GENERAL ELECTRIC

Subject: HANDOUTS FOR GENERIC MARK III MEETING

PSTF ONE-THIRD SCALE
POOL SWELL STRUCTURAL TESTING

RELAP 4 ANALYSIS
OF REACTOR SHIELD
WALL PRESSURE TRANSIENTS

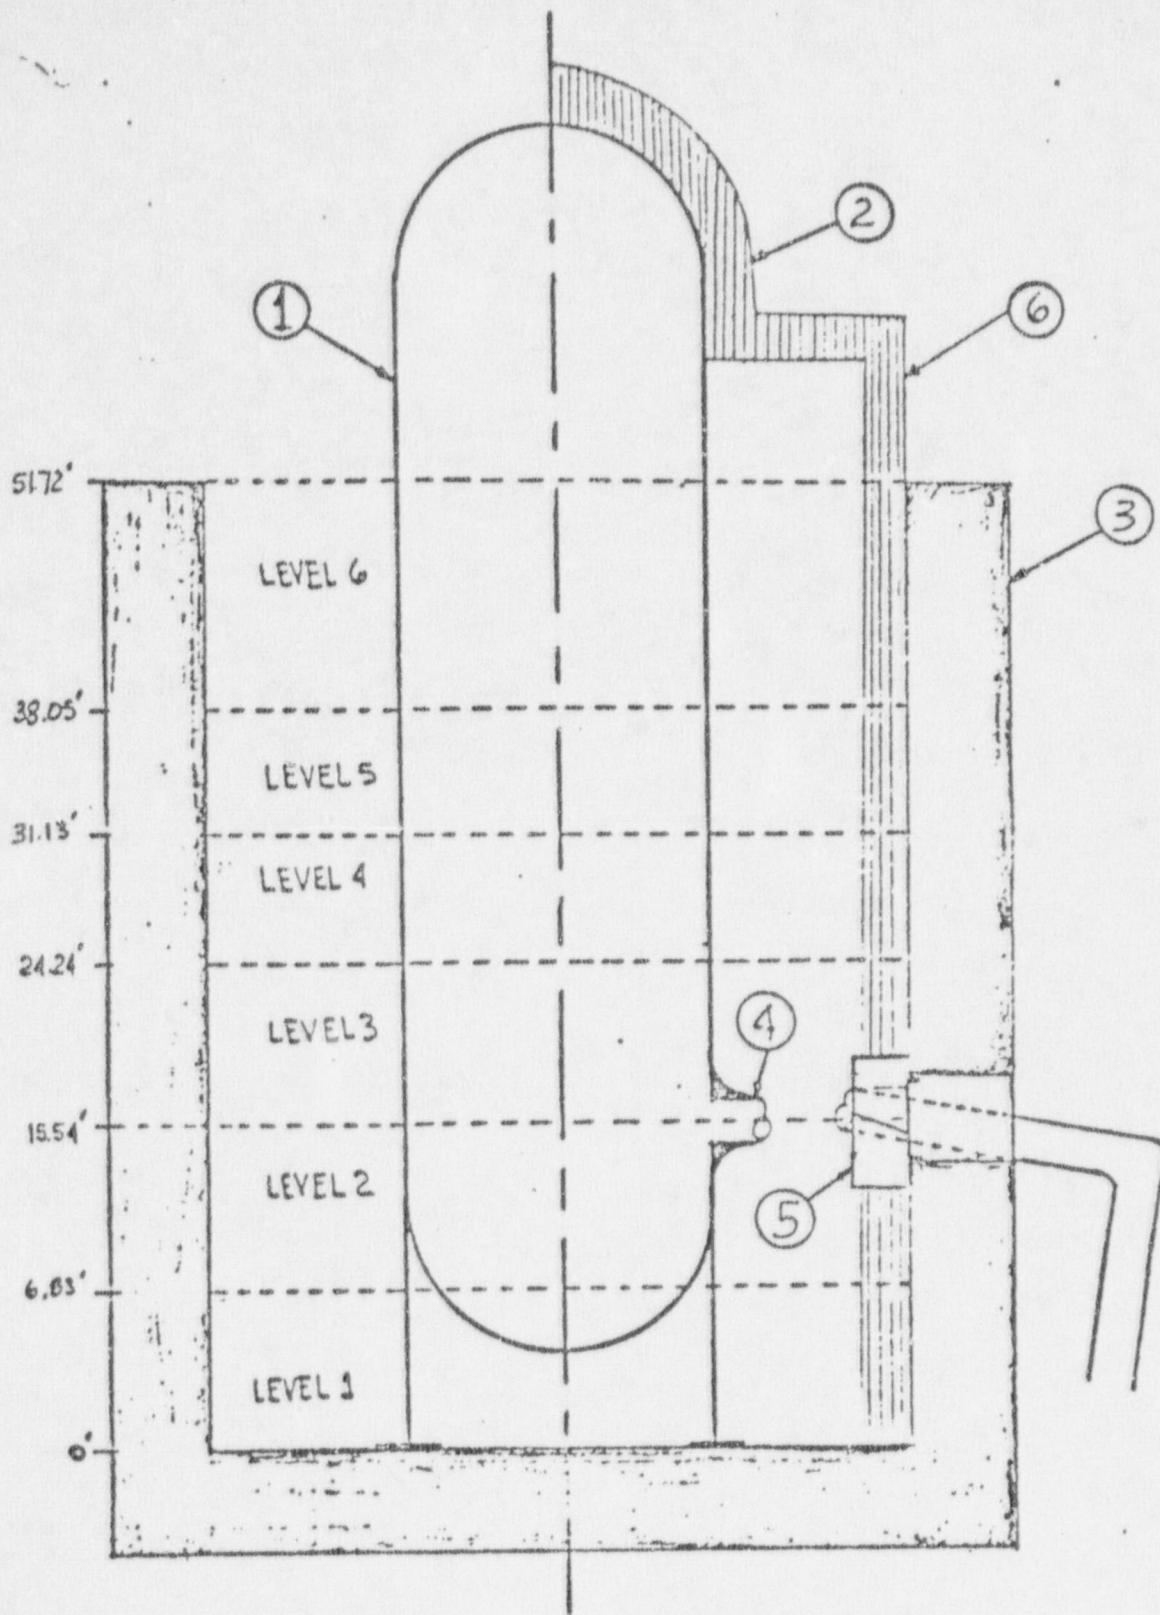
6. Provide a description of the nodal arrangement, area volumes, flow areas, loss coefficients, and the philosophy used in selecting these values in the subcompartment analysis for the RPV shield wall annulus.

This information will be provided in a letter transmitted to you by April 4, 1975.
